TECHNICAL BULLETIN

No. 4 of 2018

Solenoid Power Supply / Controller Compatibility

ORP Monitoring

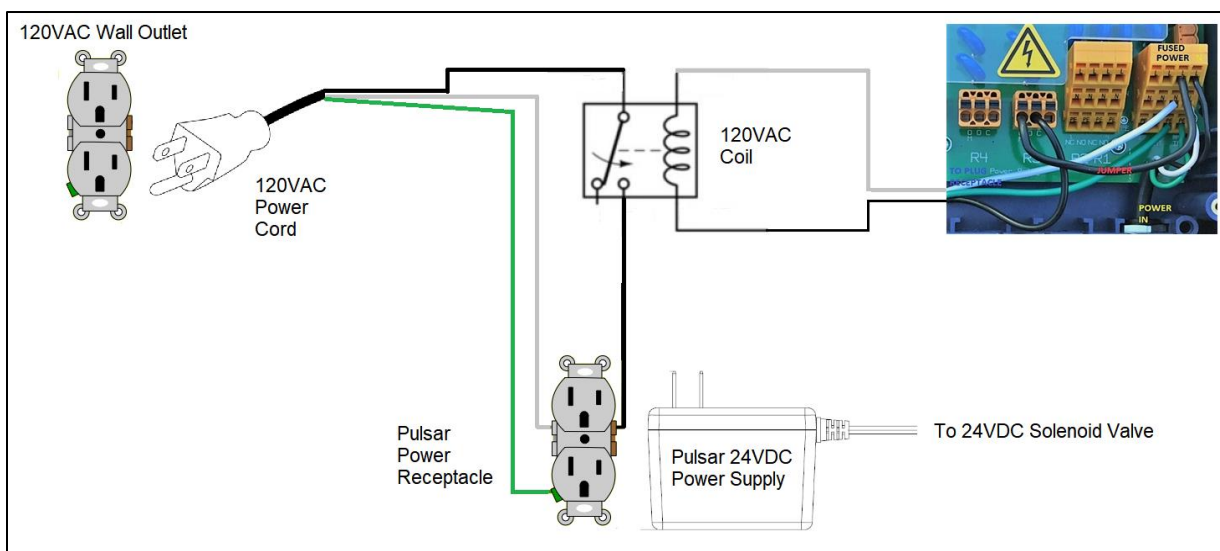
A compatibility issue exists between the **Pulsar®** Infinity solenoid 24V DC power supply and prominent DCM series chemical controllers when the power supply is directly plugged into the controller. The inrush current to the 24V DC power supply of 70 – 140 Amps far exceeds the designed capacity of the DCM controller 10 Amp relays. Excessive current of this nature can cause relay contacts to remain on (stick) and allow chemicals to feed after the controller has turned off the relay. Although it occurs intermittently, this situation can lead to over feeding chlorine in the pool and overshooting the ORP set point.

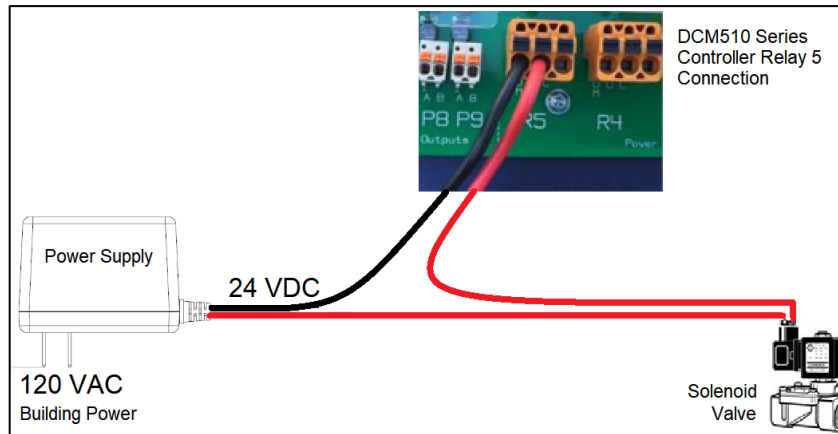
1. Use an isolation relay to isolate the controller from the excessive inrush current of the solenoid 24V DC power supply. The drawing below represents an example of how to wire an isolation relay.
